Report on a Publicly Notified Resource Consent Application

(Section 42A)

Application number:	RMA/2024/576
Applicant:	Cambridge 137 Limited
Site address:	137 Cambridge Terrace
Legal description:	Pt Lot 1 DP6773, Pt Lot 1 DP6773
Zone:	
District Plan:	City Centre Zone
Overlays and map notations:	
District Plan:	Downstream waterway setback 30m Ngā Tūranga Tūpuna - abutting Ngā Wai - adjacent Significant Feature - adjacent Site of Ecological Significance - adjacent Flood Management Area Central City Core Overlay Central City Inner Zone Liquefaction Management Area
Road classification:	Central City Local Distributor Central City Main Distributor
Activity status:	Discretionary Activity
Description of application:	Demolition of a heritage building (Harley Chambers) and construction of a hotel.
Submissions:	27 in support 1 in support but seeks changes 2 in opposition 1 in opposition but seeks changes 1 'does not oppose' 1 'neutral' (5 submitters have indicated they seek to be heard)

Date of Hearing:	17 and 18 October 2024
Recommendation:	Grant subject to conditions

Figure 1: Ground floor plan

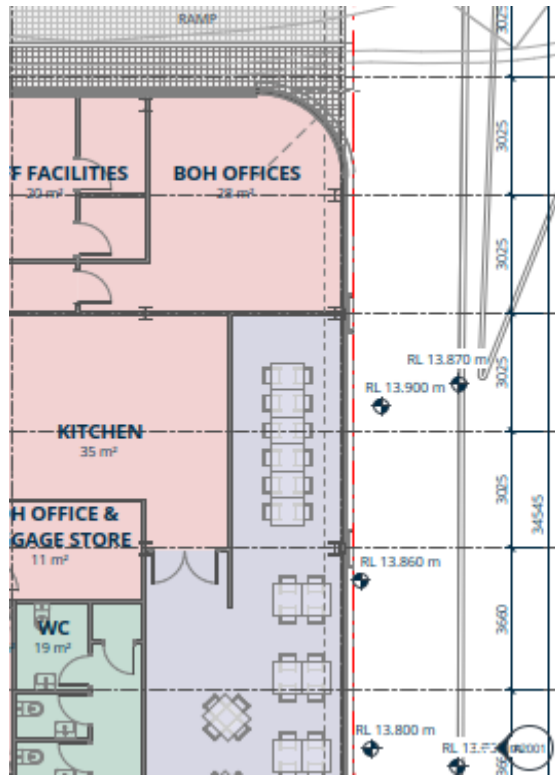
103. Ms Sakin's conclusion is that:
- There should be a setback from third floor where there is a difference in cladding design so that there is a better fit with the context of the site that she has identified. Provided this road wall height is achieved the overall height of the proposed building is not an issue.

- There should be a setback from around the 32m – 35m height from the northern boundary of 5m (I understand this to be about the 9th level).
 - There should be a pedestrian entrance on Cambridge Terrace in the vicinity of the long table shown on this floor plan:

108. I conclude that a setback in the façade is necessary at some point. I note that Ms Sakin’s conclusion in her option 1 would conflict with the bus circulation that has been carefully considered so that, with conditions, it is safe and efficient, and necessary to provide for client’s of the hotel who I understand, from discussions with the applicant, a large number of which will be brought to the site by bus.

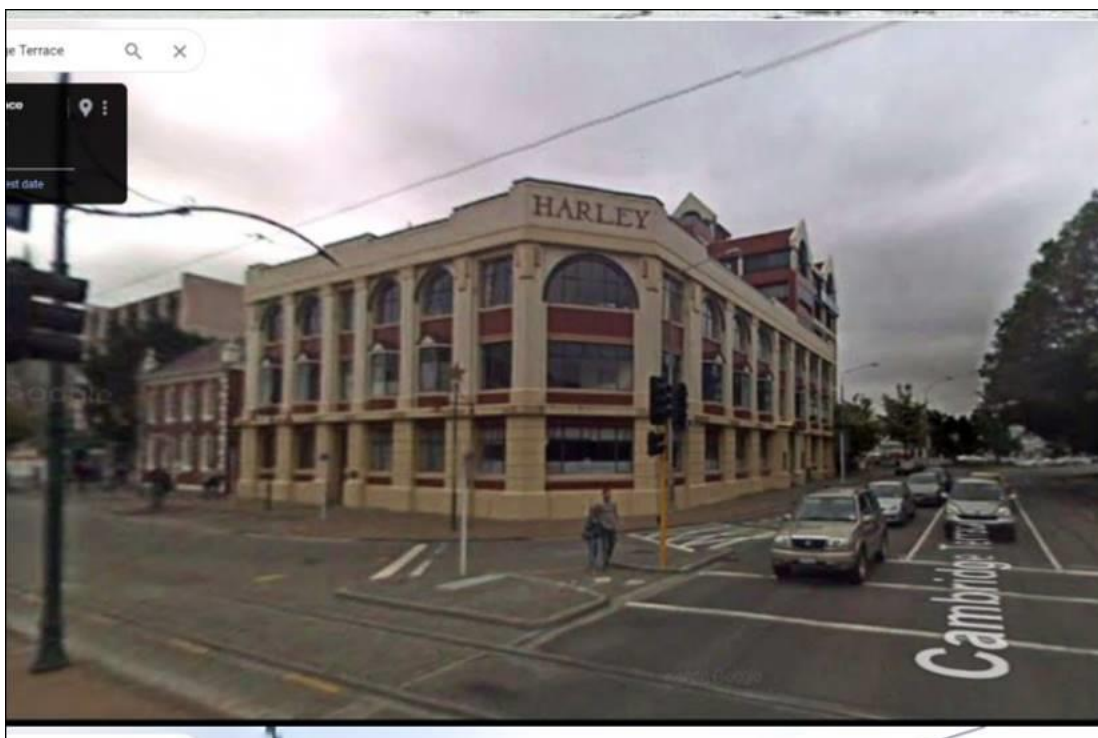
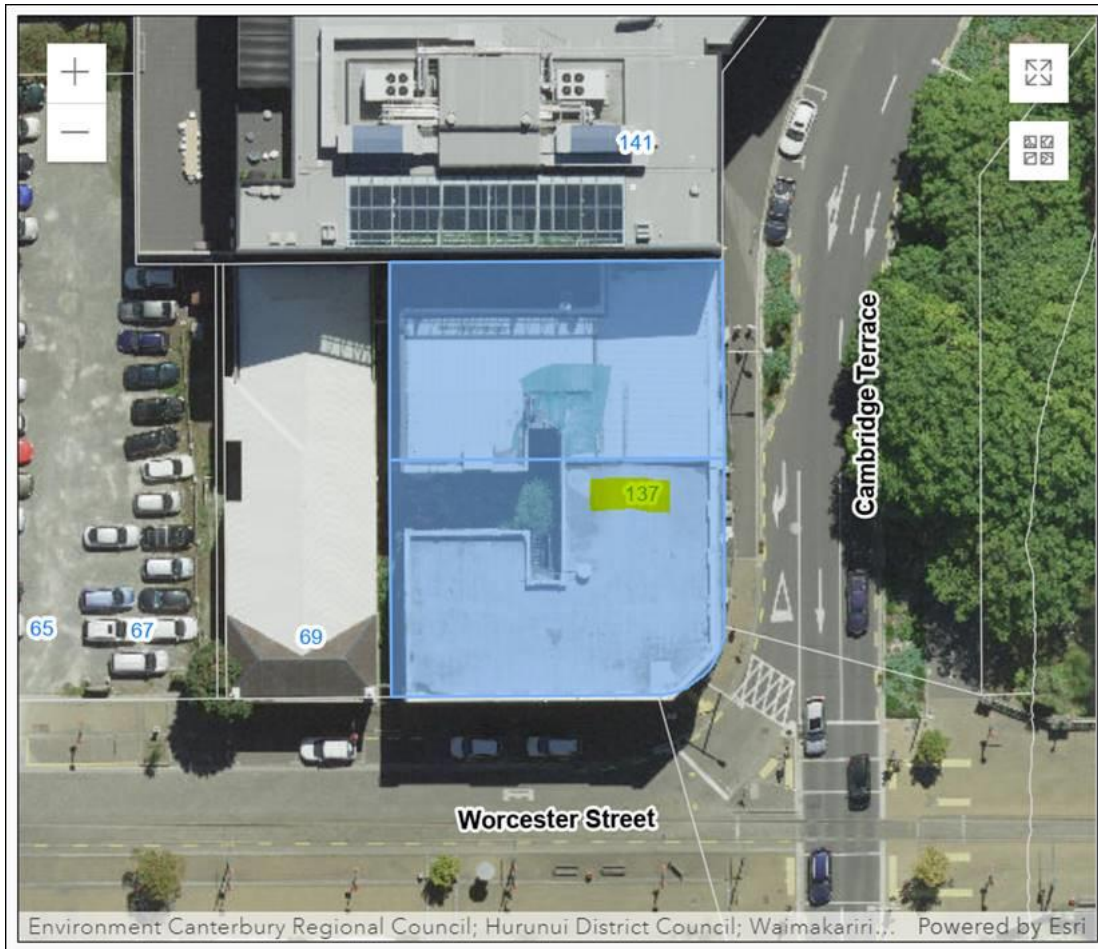
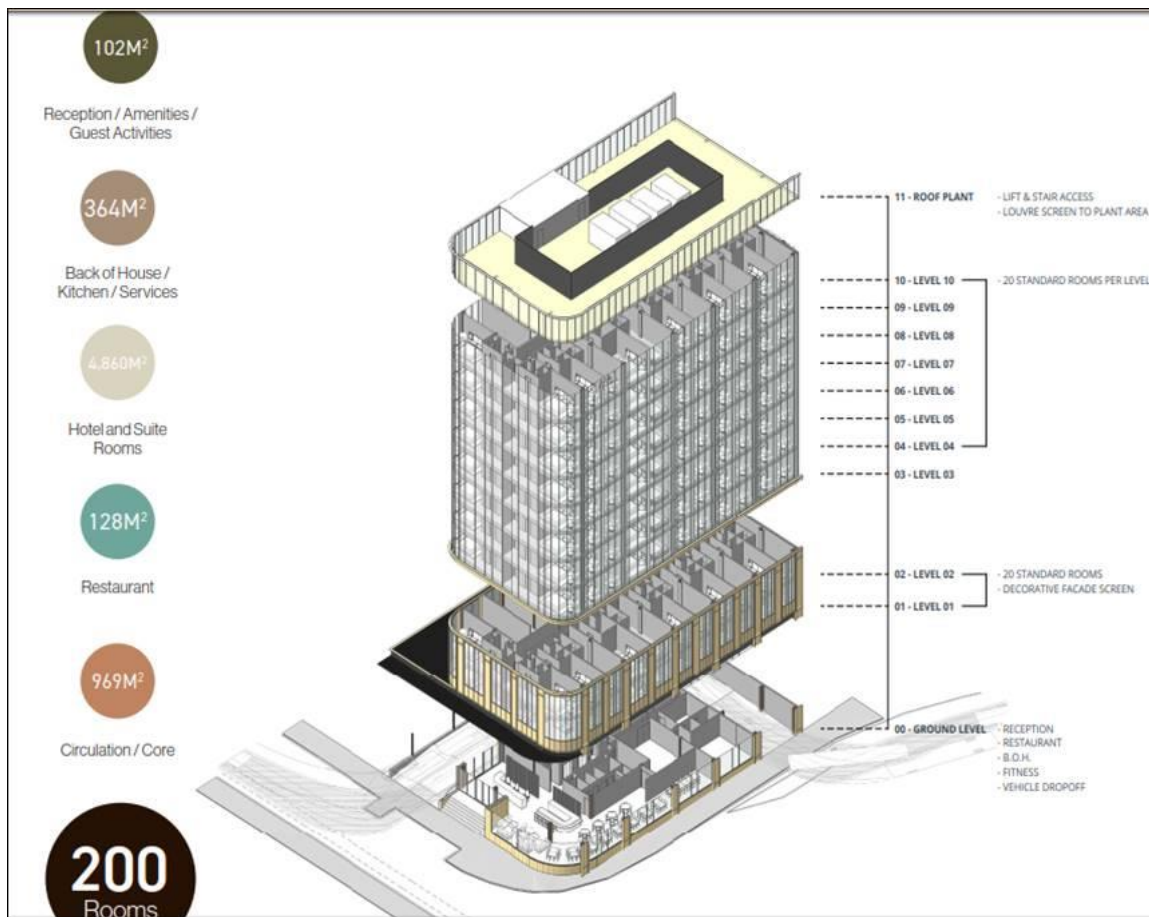
Any loose fill to be replaced with compacted hardfill.

Any site contamination, e.g. old tanks to be removed.

- The site has no **HAIL** activities listed
- ESCP to be provided
- Full Geotechnical report with foundation recommendations to be provided at building consenting stage
- Weather conditions (e.g. heavy rain) to be monitored during earthworks

- All earthworks to be carried out in accordance with NZS 4431
- Run-off must be controlled/ monitored
- Dust control
- Noise control
- Archaeological specialists to be incorporated
- Heavy machinery to be selected carefully
- Traffic management plan to be applied for as provided
- Ground shaking to be monitored
- Watercart as required
- ECAN guidance's for stock piles and building material storage to be followed.

Recommended site conditions, 1-8.
